**RAI Volume 3, Chapter 2.2.1.3.7, First Set, Number 1:**

Describe how UZ transport model results support the integration of transport processes in terms of the UZ barrier components and the relative importance of the transport processes.

Basis: Additional information is needed from model results to compare the activity releases from the matrix continuum, the fracture continuum, and faults at the water table and at intermediate locations within the UZ (e.g., base of the TSw, base of the CHn (vitric facies), base of the CHn (zeolitic facies)). The information is needed to verify compliance with 10 CFR 63.114(a) and (b).

Figure 1.1. Tracer Concentrations in Applied Infiltrating Water and Seepage Water in Alcove 1

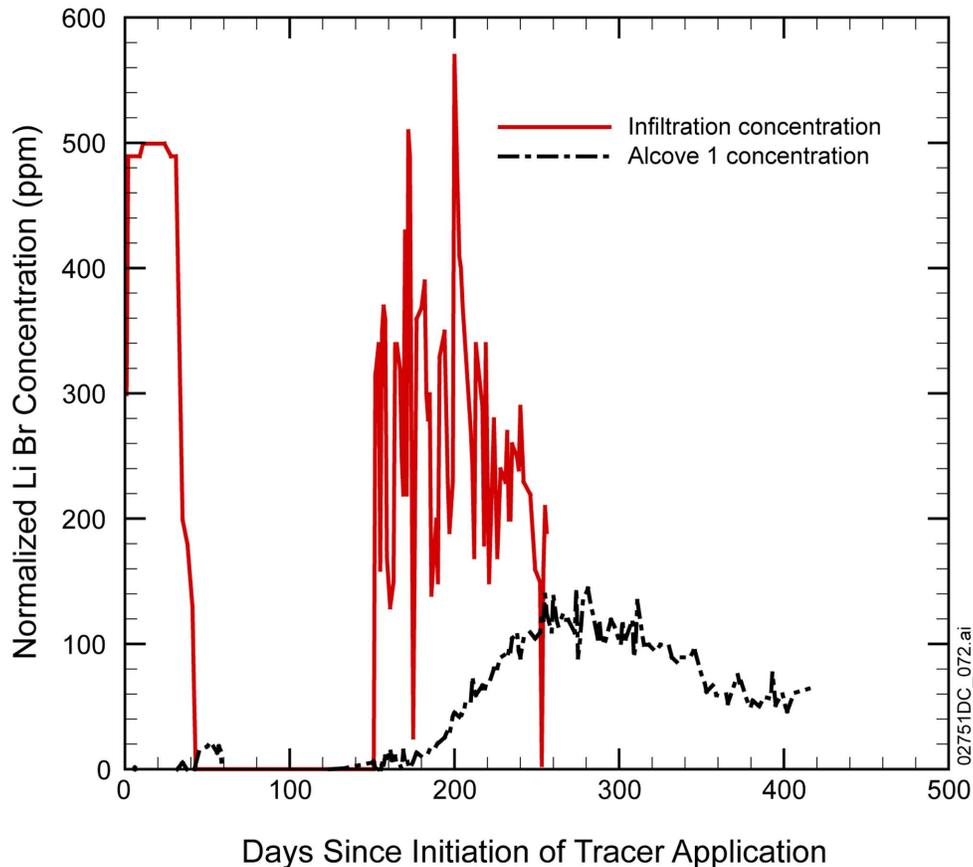
Basis: Figures 2.3.8-34 and -35, referred to in Section 2.3.8.4.4.5 of the SAR, show applied bromide tracer concentrations that fluctuated irregularly from 150 to 600 ppm over a period of approximately 100 days and observed seepage tracer concentrations that increased from 0 to 150 ppm in a relatively smoother curve approximately one month after the initiation of the tracer application. It is not apparent how much retardation of the tracer occurred relative to the infiltration rate, why the applied tracer concentration varied so irregularly as part of the experiment, how the fluctuating initial concentration was addressed in the interpretation of results and subsequent modeling, or what percentage of tracer mass was recovered relative to that applied. This information is needed to verify compliance with 10 CFR Part 63.114(g).

Tracer transport rates in Alcove 1 are based on tracer breakthrough behavior shown in Figure 1.1. The time origin on this plot corresponds to May 18, 1999, about 14 months after the beginning of water release into the infiltration plot at Alcove 1. This analysis focuses on the second tracer application because of the stronger response in the tracer concentrations measured in Alcove 1 seepage water as compared with the first tracer application. The second tracer injection began on day 152 on Figure 1.1. Tracer injection concentrations are highly variable during the second tracer application (see Section 1.4), but an average injection concentration was about 266 ppm. The tracer response reached a peak concentration in Alcove 1 seepage water of about 133 ppm at about day 255. After this peak concentration is reached, the tracer concentration in Alcove 1 seepage water began to decrease in response to the termination of tracer in the infiltrating water at the ground surface.

The lithium bromide tracer concentrations applied at the ground surface for the Alcove 1 transport tests also displayed relatively high amplitude fluctuations, from about 150 to 600 ppm as shown in Figure 1.1. The samples collected to analyze the bromide concentrations were taken from the drip lines used to distribute the source water and tracer in the infiltration plot. The bromide concentration fluctuations were caused by: (1) supersaturation of bromide solution resulting in precipitation of bromide in the solution supply bucket; (2) incomplete mixing of the lithium bromide in the supply solution bucket; and (3) batch bromide analyses that introduced a time delay (on the order of a week) in correcting deviations in solution concentration.

Figure 2. Cumulative Mass Released of  $^{99}\text{Tc}$  and  $^{242}\text{Pu}$  from the Engineered Barrier System, Unsaturated Zone and Saturated Zone for Realization 4,641 of the Seismic Ground Motion Modeling Case for the 1-Million-Year Period after Repository Closure (SAR Figure 2.4-108)

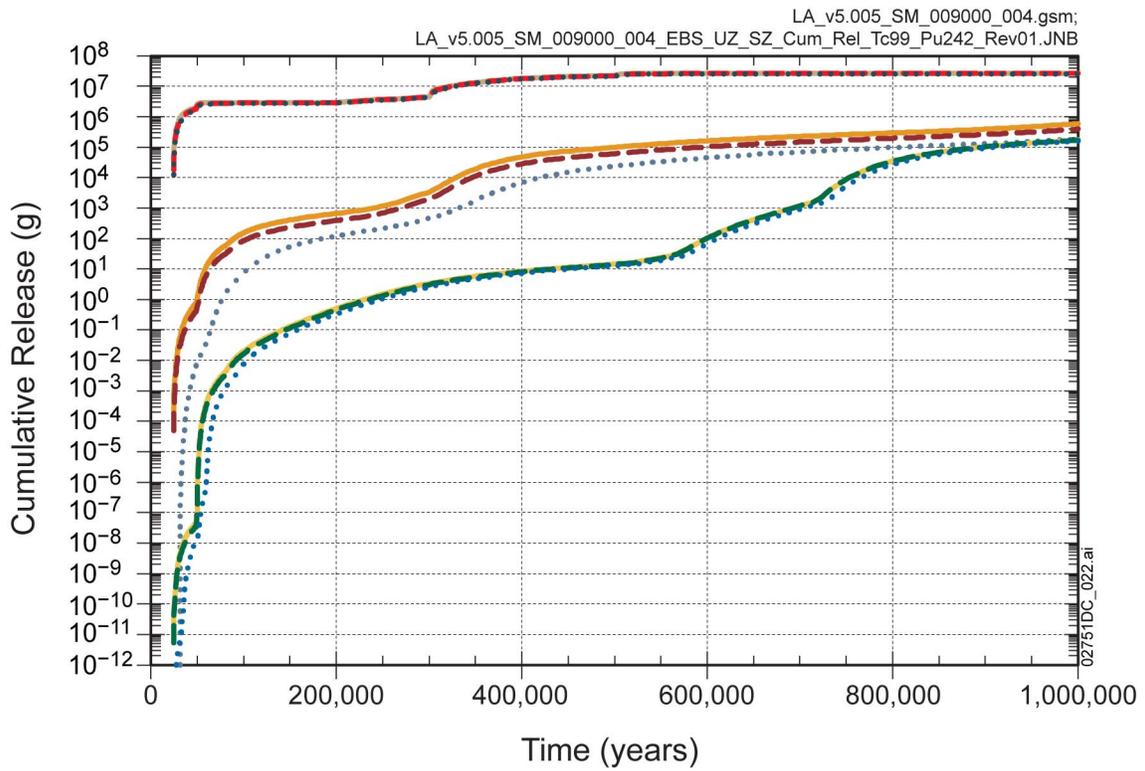
Basis: Modeling results presented in the SAR indicate that plutonium is transported more readily through the UZ as a solute or reversible colloid than as an irreversible colloid. The modeled arrival time of irreversible colloids is longer than and contributes less to <sup>242</sup>Pu activity releases from the UZ than the dissolved and reversible colloids in the UZ (e.g., SAR Fig. 2.4-108). However, results presented elsewhere in the SAR indicate that irreversible colloids have short travel times in the UZ (e.g., SAR Section 2.3.8.5.4). The information is needed to verify compliance with 10 CFR 63.114(a) and (b).

SAR Figure 2.4-108 (see Figure 2) contains three sets of curves. One set is comprised of the EBS, unsaturated zone, and saturated zone cumulative releases of  $^{99}\text{Tc}$ . The second set is comprised of the EBS, unsaturated zone, and saturated zone cumulative releases of  $^{242}\text{Pu}$  migrating as a combined dissolved phase and reversibly sorbed to a smectite colloid phase. The third set is comprised of the cumulative EBS, unsaturated zone, and saturated zone releases of  $^{242}\text{Pu}$  irreversibly sorbed to both waste-form colloids and iron oxyhydroxide colloids. The irreversibly sorbed  $^{242}\text{Pu}$  travels through the Lower Natural Barrier (unsaturated zone and saturated zone features) as both slow (retarded) and fast (unretarded) irreversible colloids (SAR 2.3.8.5.4). The curves in SAR Figure 2.4-108 designated as “irreversible on colloids” represent the sum of the releases from the slow and fast irreversible colloids.

The initial part of the cumulative breakthrough curves must be examined to compare the relative travel times of  $^{242}\text{Pu}$  migrating as dissolved and reversibly sorbed in local equilibrium ( $^{242}\text{Pu}$  (aqueous)) with the travel time of  $^{242}\text{Pu}$  migrating as irreversibly sorbed onto colloids ( $^{242}\text{Pu}$  (irreversible on colloids)). To do this, it is necessary to expand both the y- and x-axis scales of SAR Figure 2.4-108 so that the entire transport history of both sets of  $^{242}\text{Pu}$  transport curves can be seen (see Figures 3 and 4). As can be seen in Figures 3 and 4, EBS releases for both  $^{242}\text{Pu}$  (aqueous) and  $^{242}\text{Pu}$  (irreversible on colloids) actually begin at the same time (24,500 years), which is the time of the first damaging seismic event to codisposal waste packages. This was not apparent in SAR Figure 2.4-108 because of the axis scaling. Also, the early-time cumulative mass for irreversible colloids released from the EBS is much lower than the aqueous phase releases, which apparently causes the aqueous phase arrival times to appear earlier on SAR Figure 2.4-108 with the particular x- and y-axis scales shown in that figure. The expanded scales shown in Figures 3 and 4 eliminates this graphical effect. Note that on Figures 3 and 4 the unsaturated zone releases appear to start at the same time as the EBS releases, which reflects the fact that the cumulative release curve is integrated over 500-year timesteps at 24,500 years, which is too large to distinguish initial EBS releases from initial unsaturated zone releases. These initial unsaturated zone releases represent mass transported with a relatively fast travel time through the northern portion of the repository for both aqueous  $^{242}\text{Pu}$  and irreversible  $^{242}\text{Pu}$ .

The much larger EBS aqueous release compared to irreversible colloid release in SAR Figure 2.4-108 is attributable to differences in the transport properties between aqueous and colloidal phases for early diffusion-dominated EBS releases from damaged waste packages in the seismic ground motion modeling case (i.e., diffusive transport of colloids is a very slow transport mechanism), which means that  $^{242}\text{Pu}$  release on irreversible colloids is very small. The relative difference in the amount of mass transported from the EBS as dissolved/reversibly-sorbed versus irreversibly sorbed can be seen in SAR Figures 2.4-104 and 2.4-106. Also, as is apparent from these figures, these early releases of irreversible colloids are only from codisposal waste packages (which are the only breached packages at early times in this single realization) and therefore they are waste-form or glass colloids. Furthermore, as shown in SAR Figure 2.4-104, the concentration of  $^{242}\text{Pu}$  irreversibly attached to codisposal glass waste-form colloids is very low in the first 50,000 years, indicating an unstable colloid suspension due to the high ionic strength, which is characteristic of diffusive release scenarios. This low concentration implies much lower release rates than for aqueous  $^{242}\text{Pu}$ . The high ionic strength in the
